Historic District Commission Meeting

6:00 PM - Tuesday, April 12, 2022

HDC Work Permit Staff Review

AMENDED SKETCH RECEIVED 4/5/22

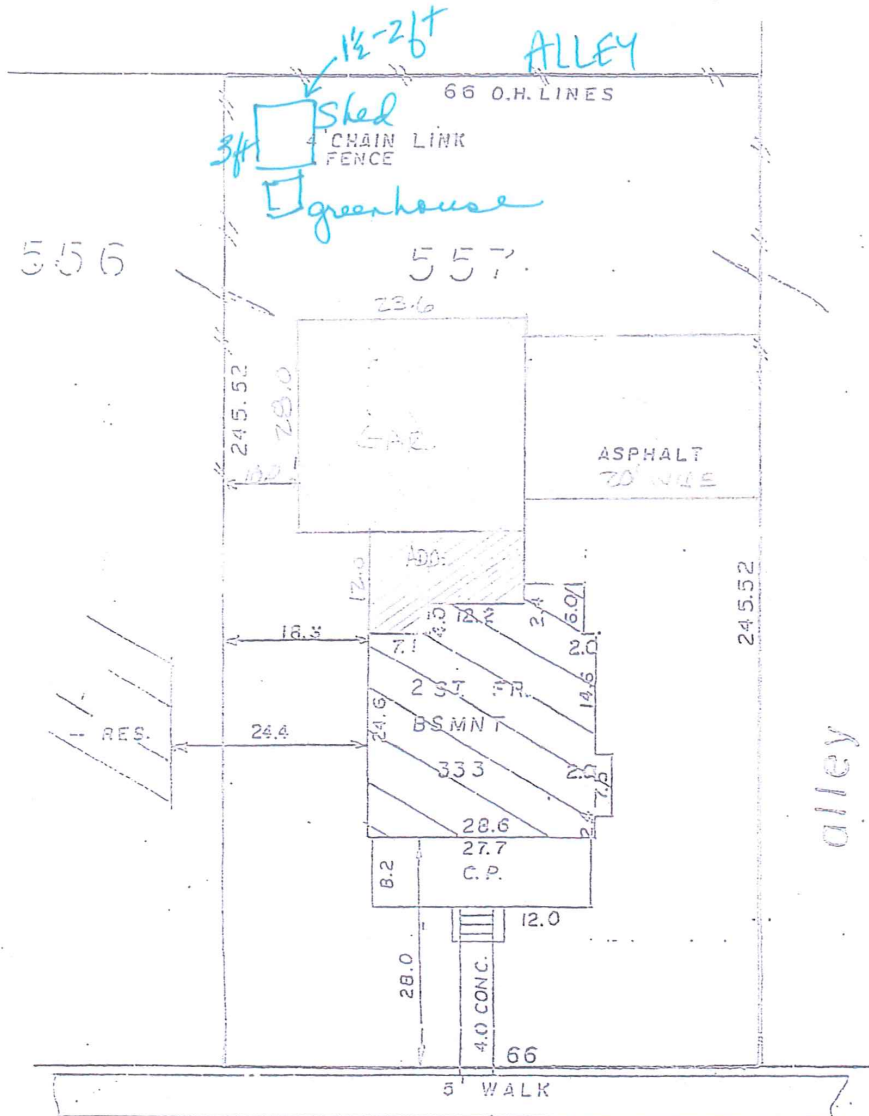
I am still deciding about
the greenhouse, if I will
get it or not, but would
only be $6 \times 4 = 24 \text{ ft}^2$

ROOF DIAGRAM #1
(NO SCALE)

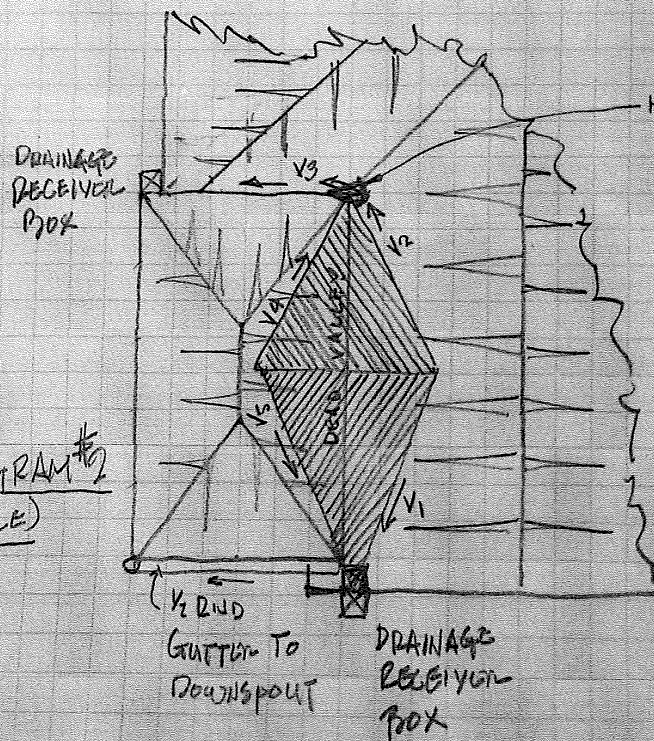
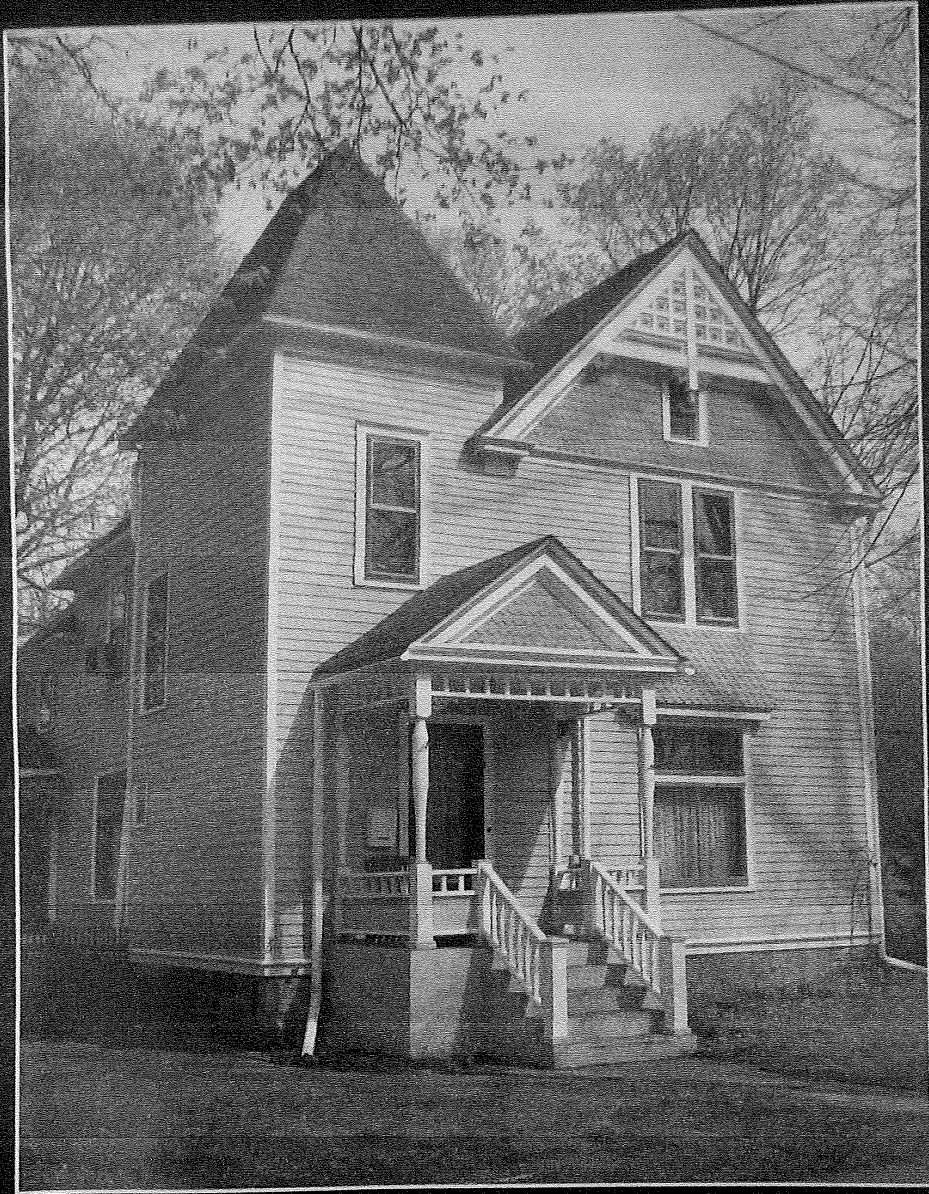
NOTE: BUILD
UP VALLEY
INVERT AT
THIS POINT
TO INCREASE
PITCH OF
VALLEY 3 (V₃)

HEAT TAPE
TO BE
APPLIED
TO ALL
VALLEY
1-5

Move to postpone the application for work received March 10, 2022 at 316 N Grove until the applicant has been able to complete measured drawings and can share construction drawings that will show how the new gable would appear from the street, and the commission chair and the applicant are to sign a formal extension for a new decision deadline for this application; the new deadline for a decision on this application will be [June 30, 2022], as long as both parties agree and sign the extension.

Figure 1: Building Zones

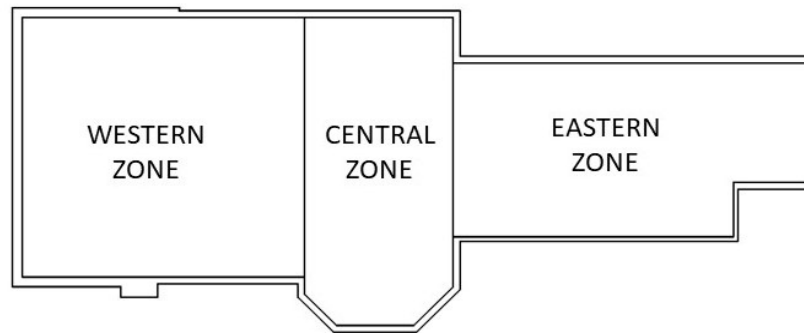
For the purposes of this report and analysis, the tower has been dividing into three zones: Eastern, Central, and Western as shown in Figure 1. The construction methods and materials are relatively uniform within the zones.

Figure 3: Eastern Zone Building Cross Section (Courtesy CDI Architects)

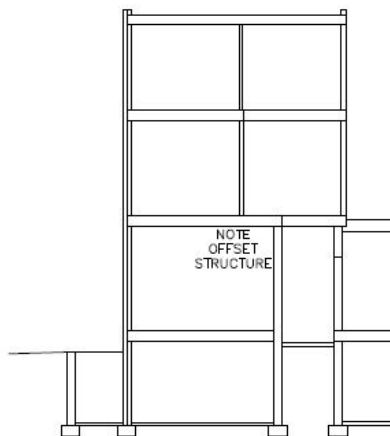
The interior bearing wall on the second and third floors is offset from the foundation by nearly two feet. This creates a situation where the second floor joists are carrying the full loading from the bearing walls above as shown in Figure 3. At the current span, the 2nd floor joists would be overloaded and not meet the minimum deflection requirements.
